Smithsonian Institution

Revitalization of the Historic Core

CONSULTING PARTIES MEETING #7

October 26, 2022

SEISMIC CONTROL JOINT GRANITE INSERT SAMPLES

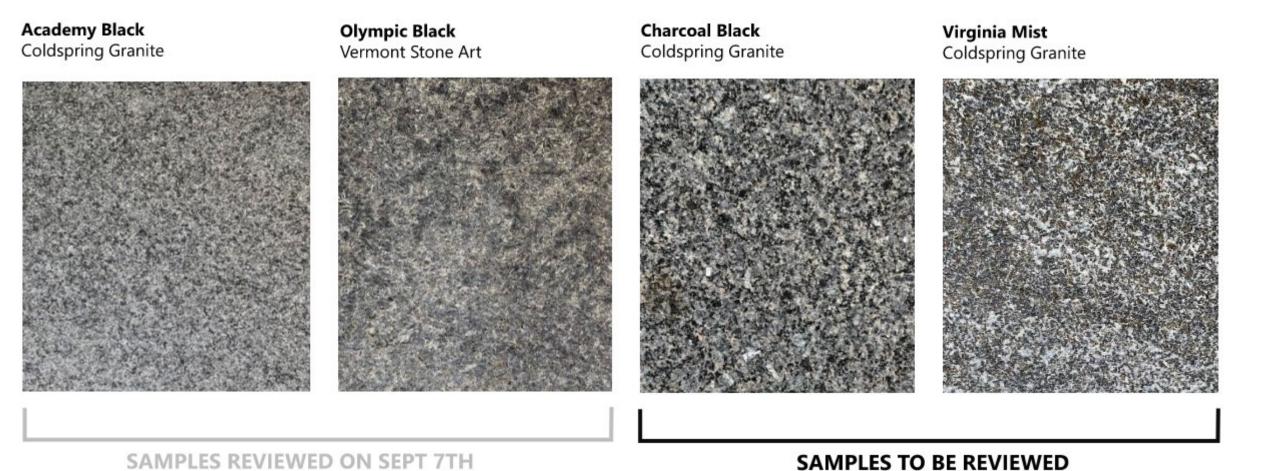
- Comments from Consulting Parties preferred the samples E (Academy Black) and F (Olympic Black)
- Consulting Parties requested a third gray granite in-between the colors and variety of Samples E and F

PERIMETER SECURITY ELEMENTS

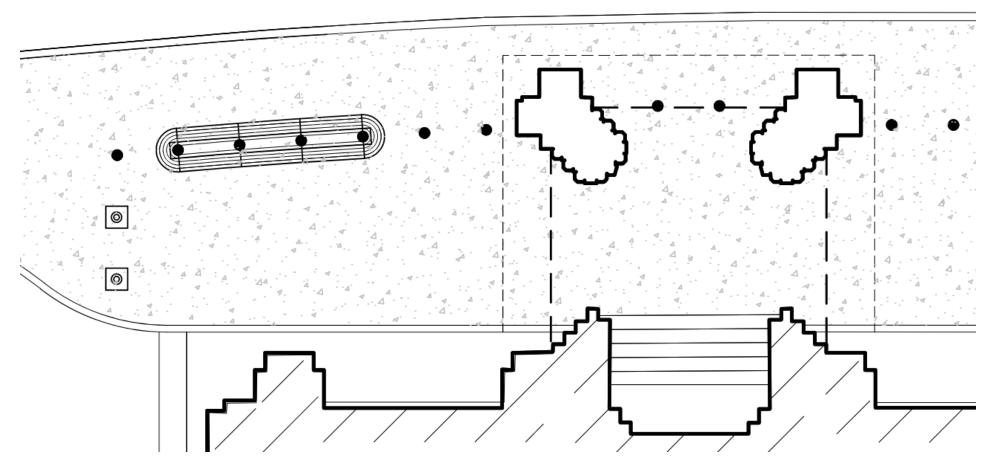
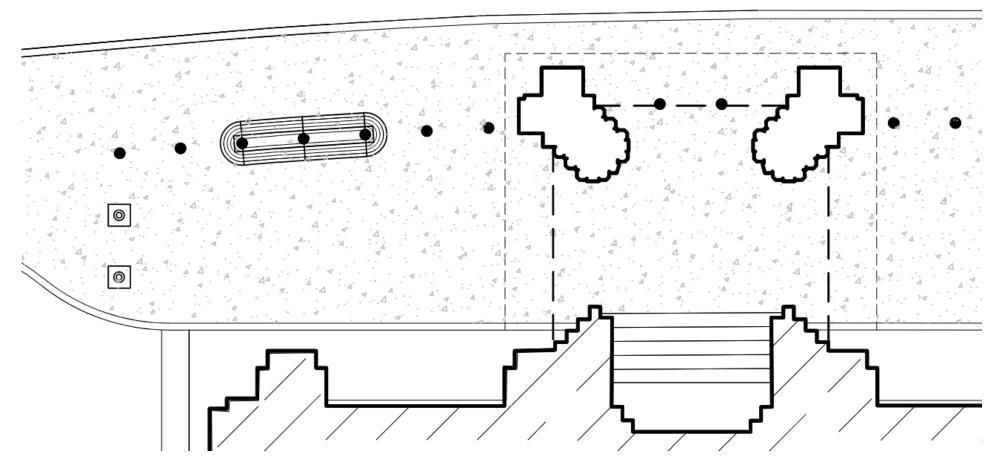
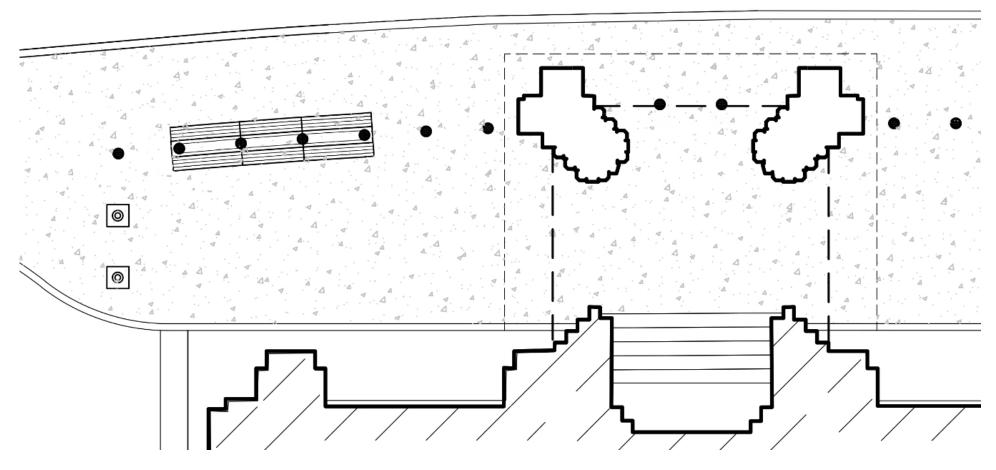
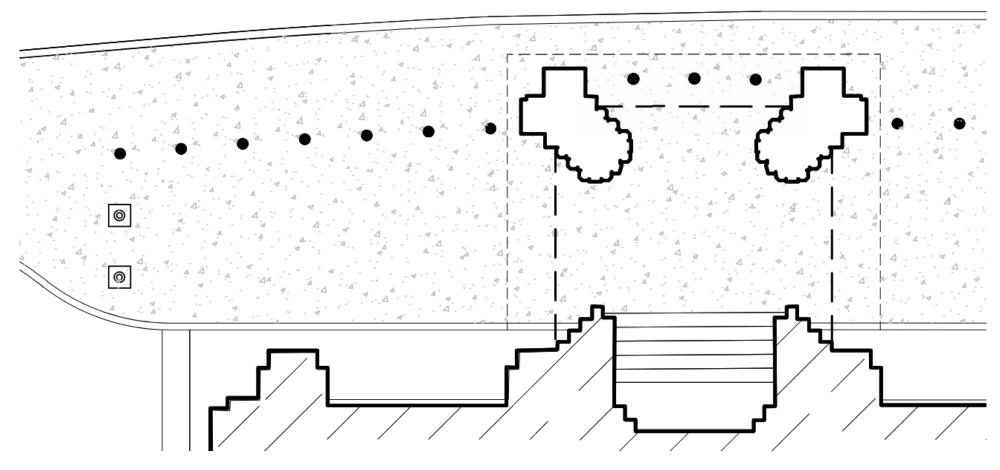
COMMENTS FROM CONSULTING PARTIES
